Access Compliance Report Public Rights-of-Way (Curb Ramps)

Main Street: ORTEGA_HWY Cross Street: ANTONIO_PKWY Location: NW

ADA ID: RPRK211118143409 Ramp Type: Type 1 - Perpendicular Initial Pass/Fail: Fail Overall Compliance: No Severity Score: 16

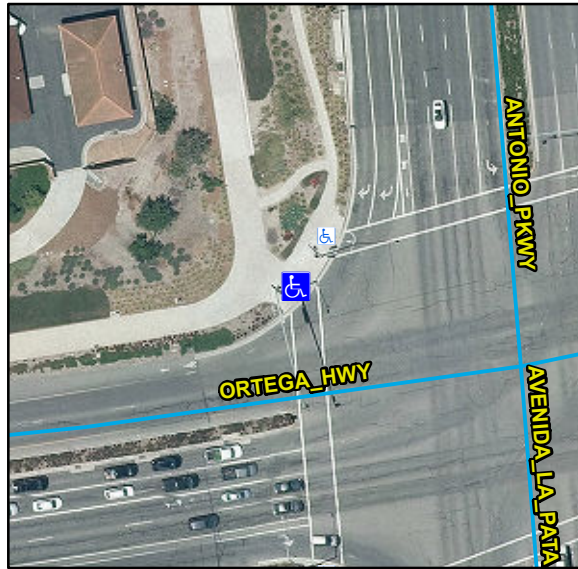
R304.2.2, R304.5.3, STD 1115

Remove & Replace Entire Ramp.
